# Determination 2024/006

**The refusal to issue a certificate of acceptance for building work associated with a dwelling**

**73A Gledstane Road, Stanmore Bay, Whangaparāoa**

Figure 2: As-built bracing plan copied from Sheet A201, dated 07/11/21 (not to scale).

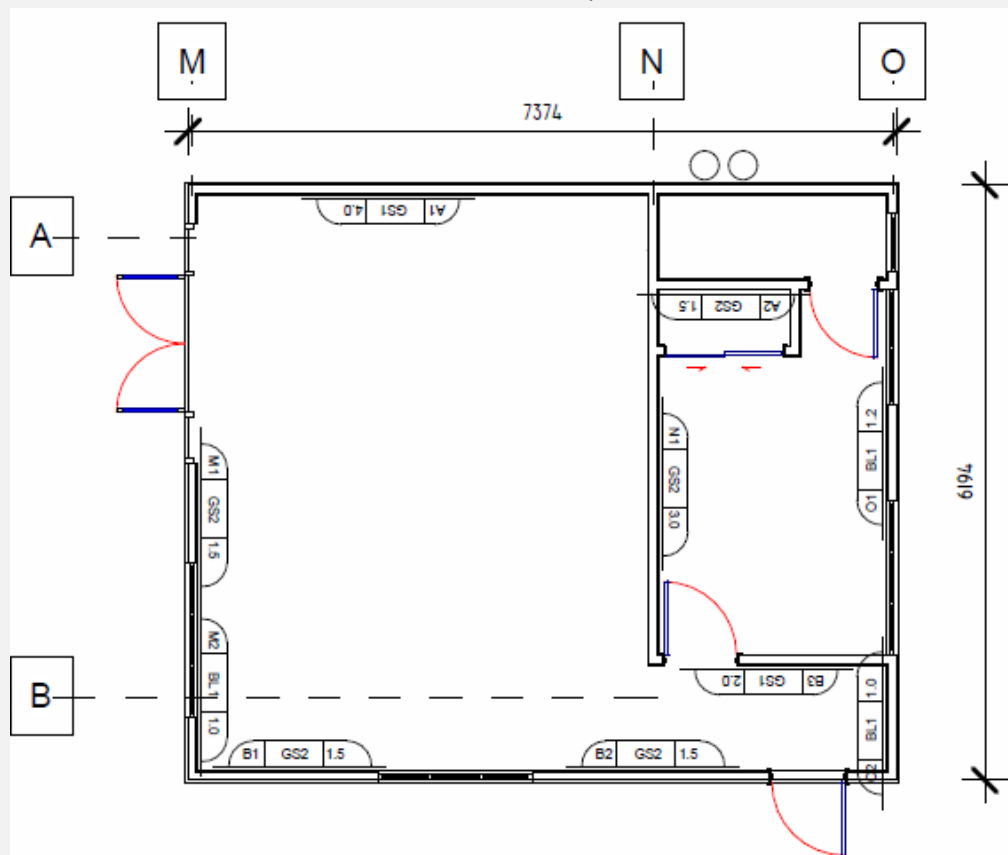
Clause B1 <i>Structure</i> : In terms of the bracing	
Authority's view	<p>The refusal report noted:</p> <ul style="list-style-type: none"> <li>The amended plans have the same date as the application plans (07/11/21) and there is no revision number provided.</li> <li>"Sheet A201 (Bracing) has a mix of GS1 (x 2), GS2 (x 5) and BL1-H (x 3) GS2 Braces x 3 have been placed to the external walls. The plans do not provide measurements of window sizes or open wall measurements for assessment of bracing widths".</li> <li>A suitably qualified structural engineer was "requested to be engaged to assess and provide a report". The authority assumed the engineer would carry out bracing calculations and invasive investigations as to the bracing hold downs. However, this information was not provided for consideration.</li> </ul> <p>The authority's determination submission noted:</p> <ul style="list-style-type: none"> <li>If the original certificate of acceptance bracing plans are submitted (in a subsequent certificate of acceptance application), they will need to be "recalculated and changes made to reflect accurate information, there are GS2s to the external walls... The build is complete, for the BL1-H bracing elements... verification of the hold-downs and 'Braceline' (if GIB product used) would need to be established. A suitable qualified person producing a structural report will also comment on the sub-floor bracing &amp; roof bracing which would include calculations".</li> </ul>

Ministry's conclusion	<ul style="list-style-type: none"> <li>It appears that the owner has provided inaccurate information in terms of the bracing elements shown on the bracing plan (see Figure 2) and in the associated calculations. The bracing plan and associated calculations indicate particular bracing types and lengths, which are unlikely to be installed on site. This is because:</li> </ul>

- The lengths of bracing elements specified in certain areas would be unlikely to fit into those locations, due to window locations etc. For example, element M2 is shown as a 1m long BL1. However, the length of wall in this location appears to be less than 1m.

- Elements M1, B1 and B2 are located on the external walls, and are noted as GS2 bracing elements. GS2 bracing elements require GIB lining to be installed to both sides of the framing. No evidence has been provided to confirm that these bracing elements are GS2s. Given the location of these elements on the external walls (of the type installed in this building), I consider it is unlikely that these bracing elements are GS2s.

- As such, I am not satisfied that the bracing plan and associated calculations accurately reflect what has been installed on site. I also note that the BL1 elements (at M2, O1 and O2) require a specific hold down fixture, which would have needed to be verified with specific evidence.
